**RE: Central Mercado
201 San Pedro SE
Grading and Drainage Plan
Engineer's Stamp Date: 06/11/21
Hydrology File: K18D111**

Based upon the information provided in your submittal received 06/14/2021, the Grading and Drainage Plan **is not** approved for Building Permit. The following comments need to be addressed for approval of the above referenced project:

SHEET NO:
C1

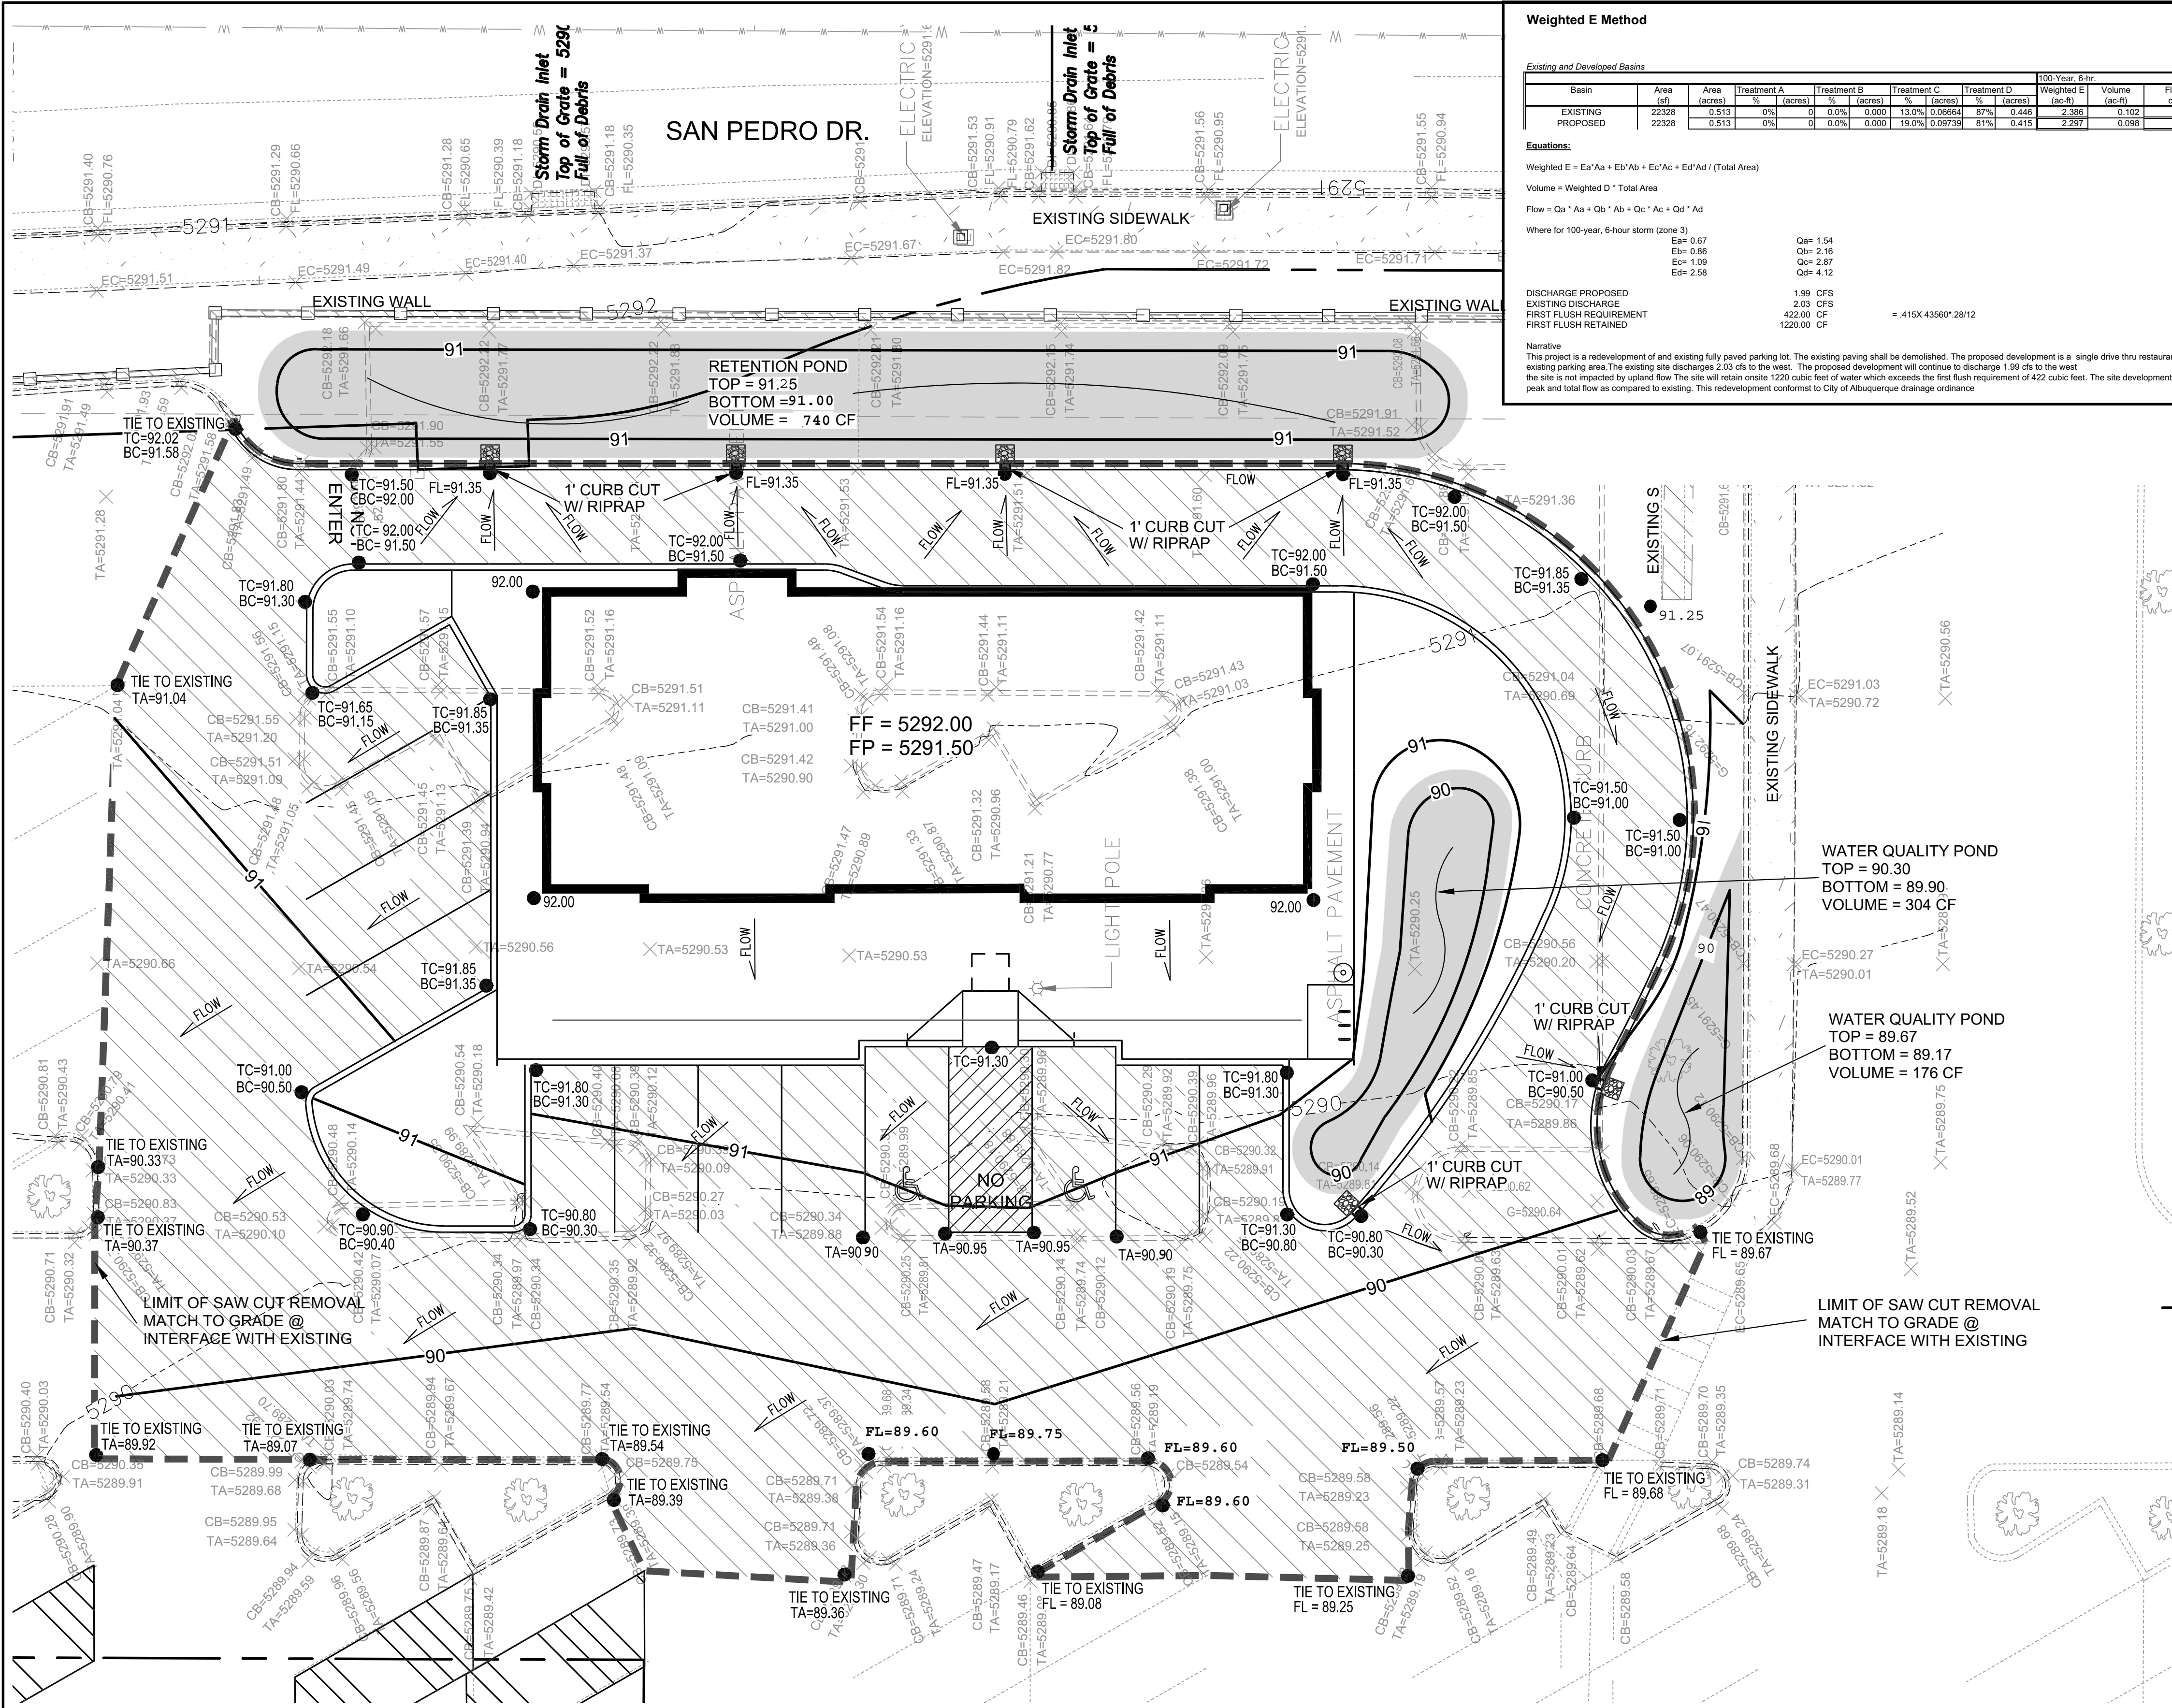
1. There will need to be a replat of the property. There is a property line going through the proposed building. A Building Permit will not be issued for a building with a property line through it. The plat will have to be submitted to the DRB (Development Review Board) for approval.

2. The drawing shows and labels an existing retaining wall. However a street view taken February 2021 does not show this existing wall. It appears that this does not exist. With this and the lot line issues, I question the existing survey information. Please provide a more accurate survey.
